#2025-08
154 S. Virginia Street – Special Use Permit &Variations
Project Review for Planning and Zoning Commission

Meeting Date: November 19, 2025

Requests: Special Use Permit for a Drive-Through Limited Service Restaurant adjacent to a residence with Variations from:

STACKING ILLUSTRATION

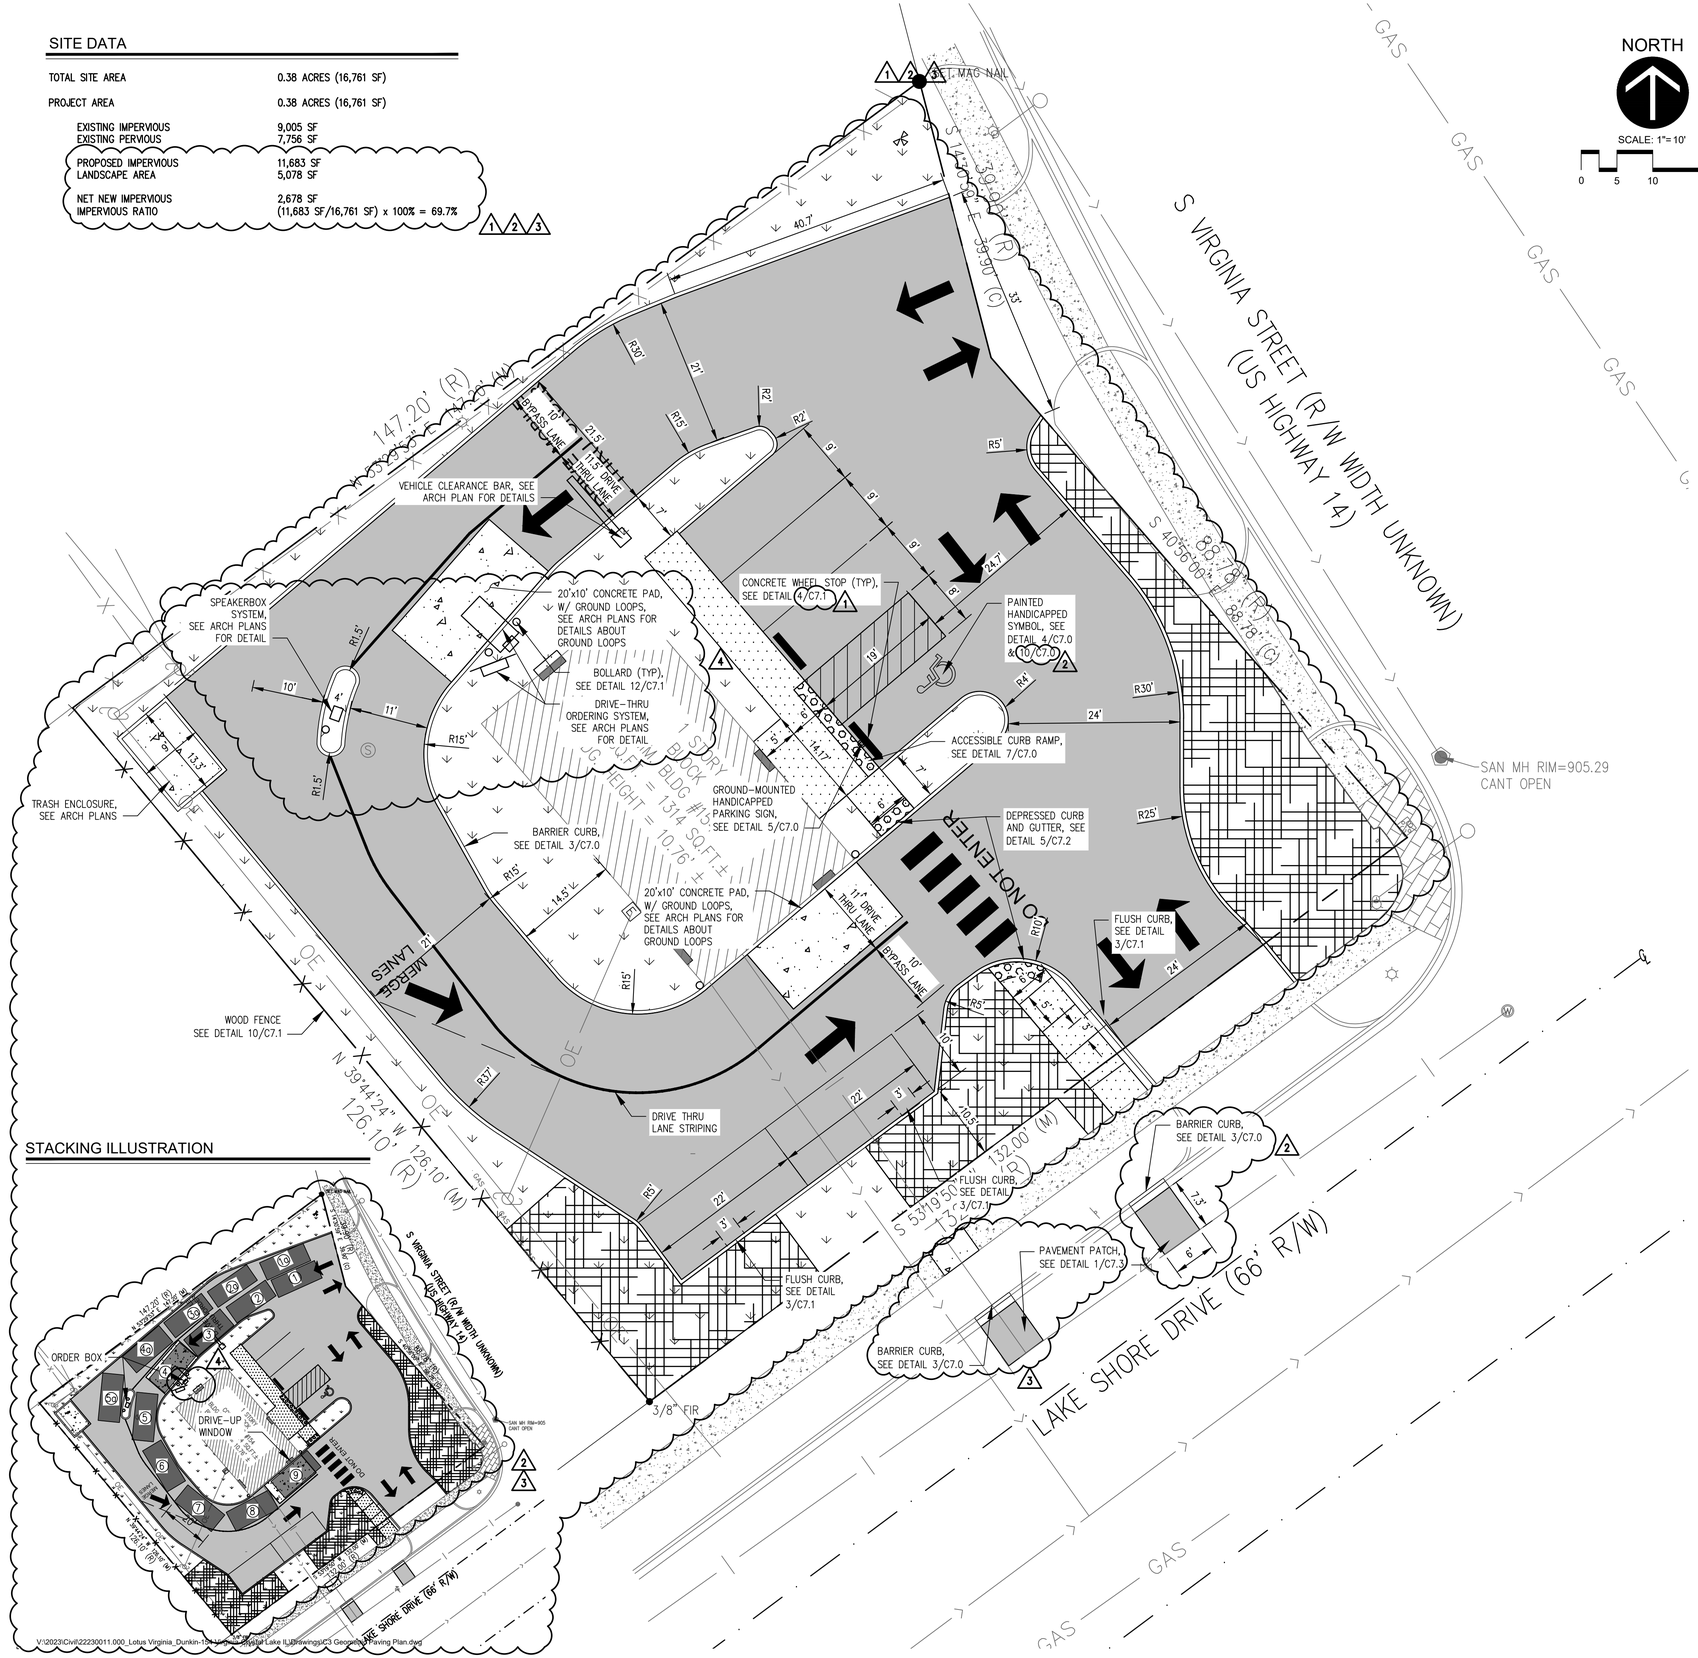
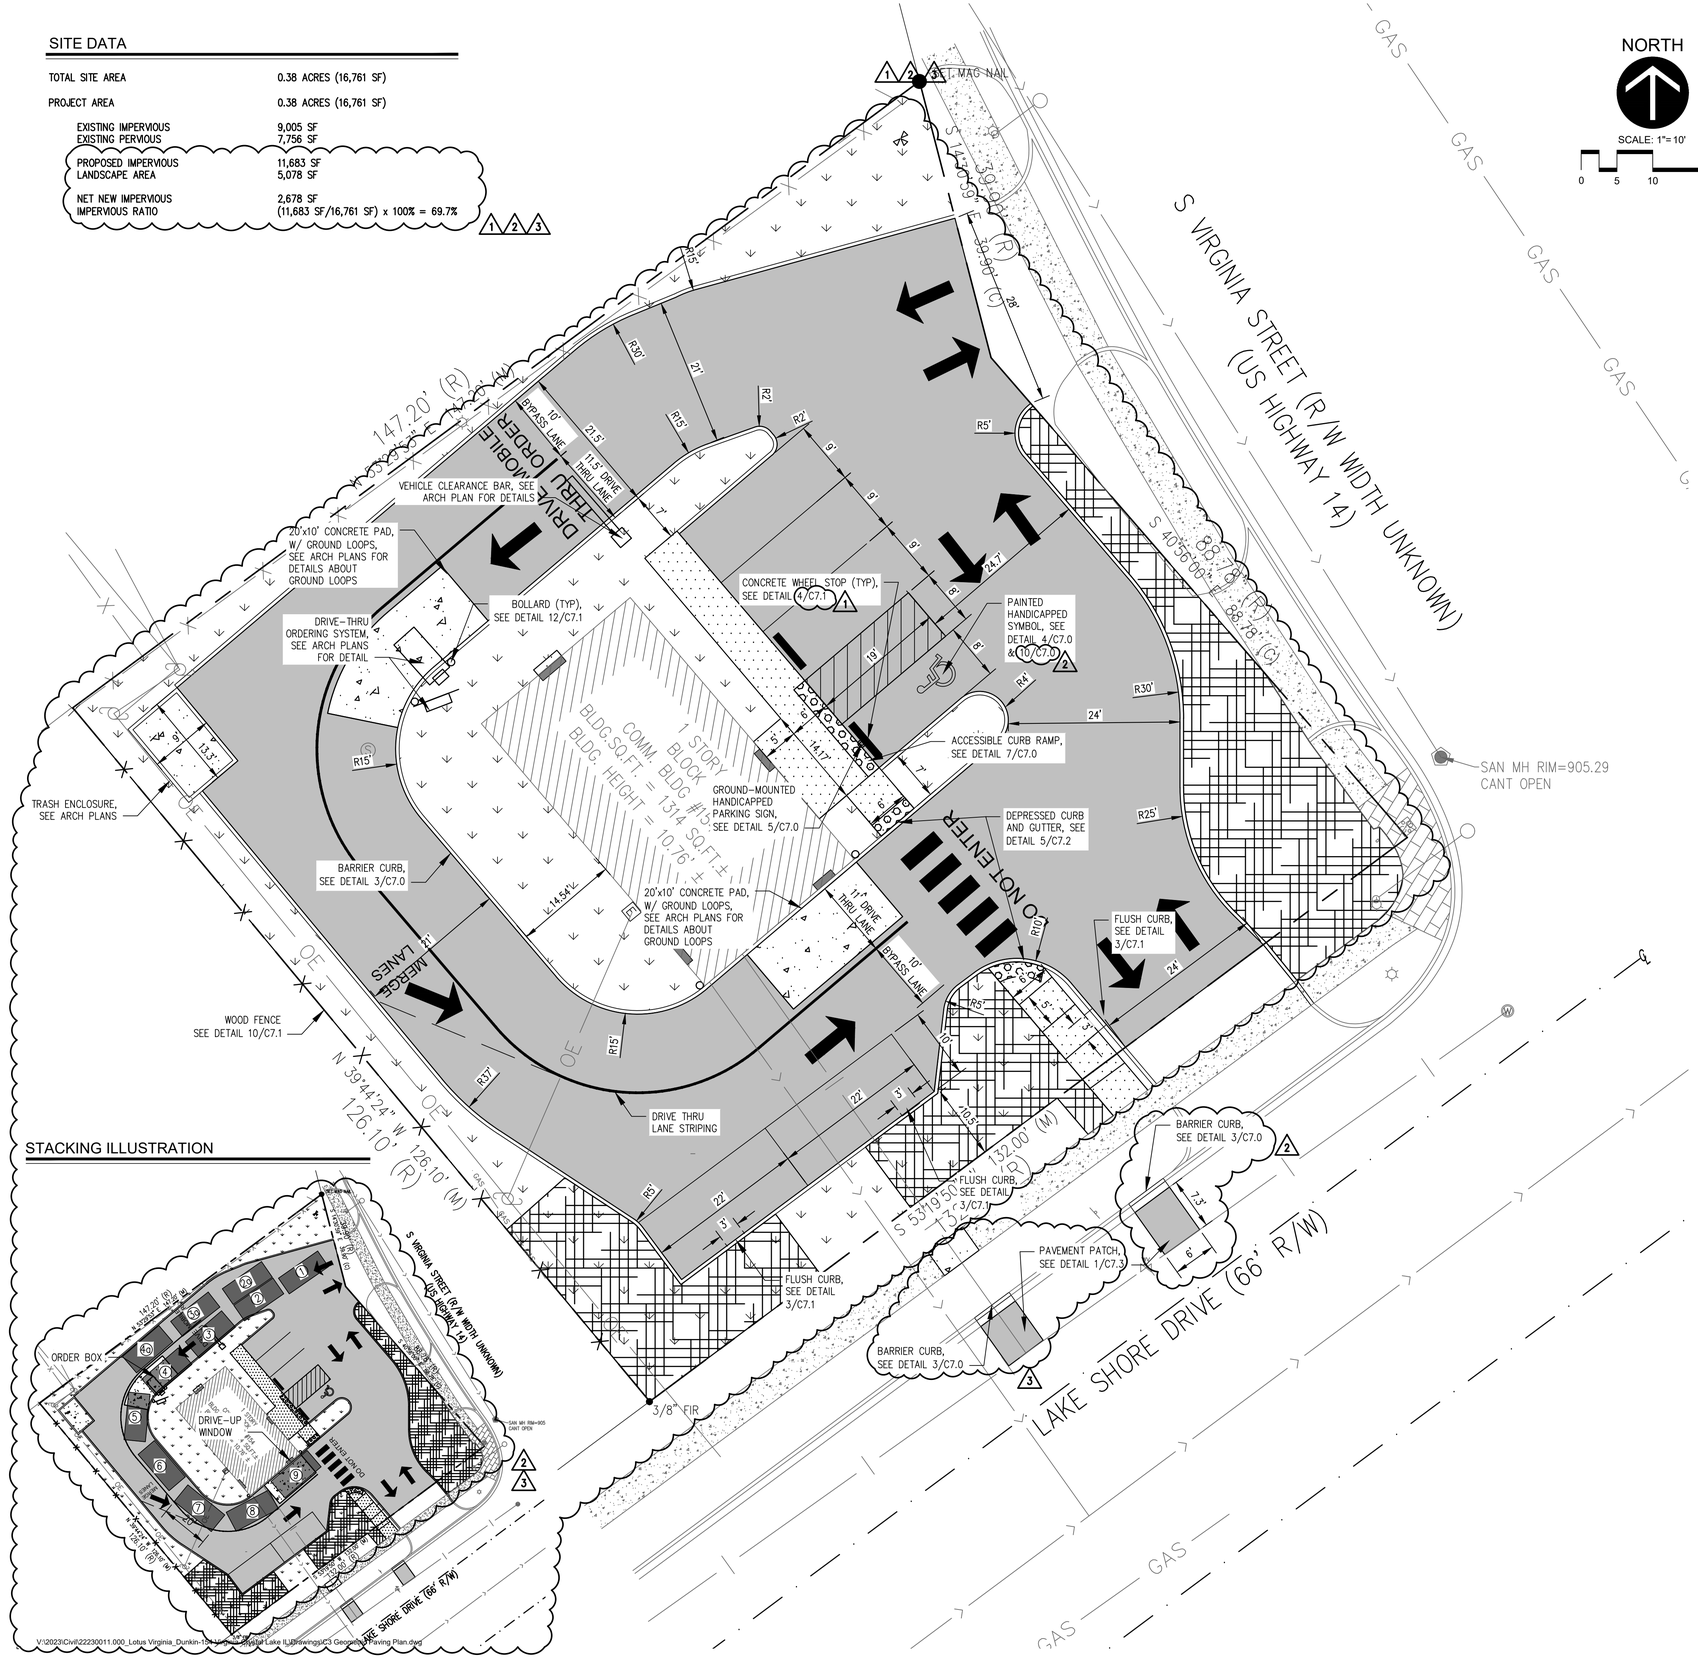
- The unscaled "Stacking Illustration" on Larson's sheet C3.0 shows nine (9) vehicles between the drive-up window and the existing curb along US Rte 14, four (4) of those from the "order sign" to the curb on US Rte 14. Three (3) additional vehicles are shown stacked in the "Mobile Order" line. Per the City's Unified Development Ordinance eight (8) spaces are required for "Restaurant, with Drive-Through Coffee/Smoothie/Donut/Bakery" sales with four (4) spaces between the "order box" and the pick-up window (which is provided).

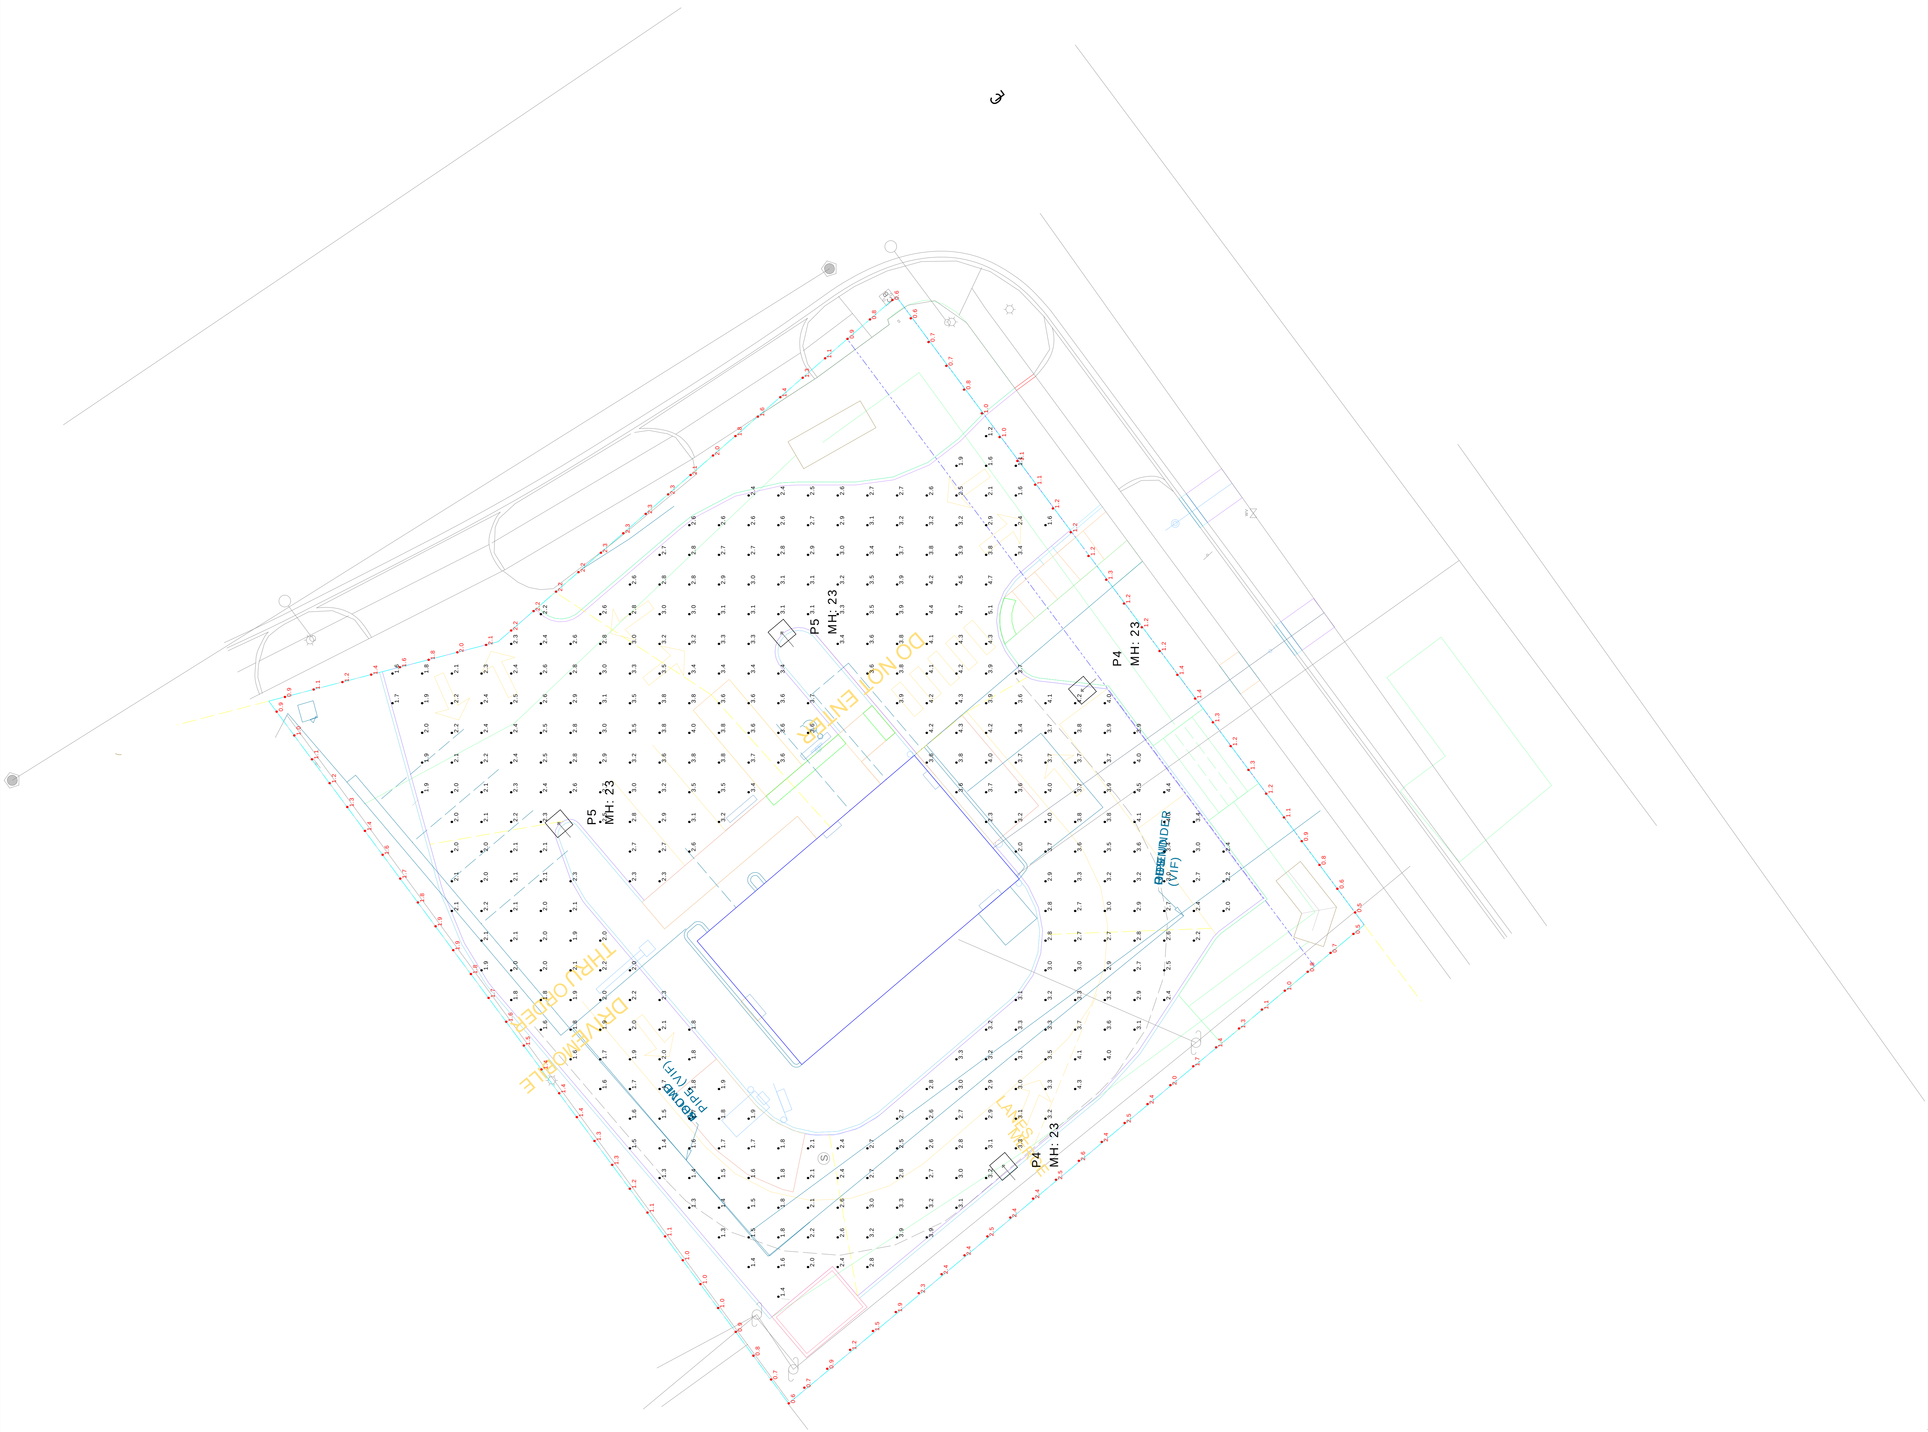
3. Lighting.
   A. The light plan must be revised to meet the ordinance of 0.3 foot candles at the property lines adjacent to residential uses.
   B. Lighting standard must meet the Virginia Street Corridor standard. Provide cut sheets for wall packs and pole lighting for staff review.
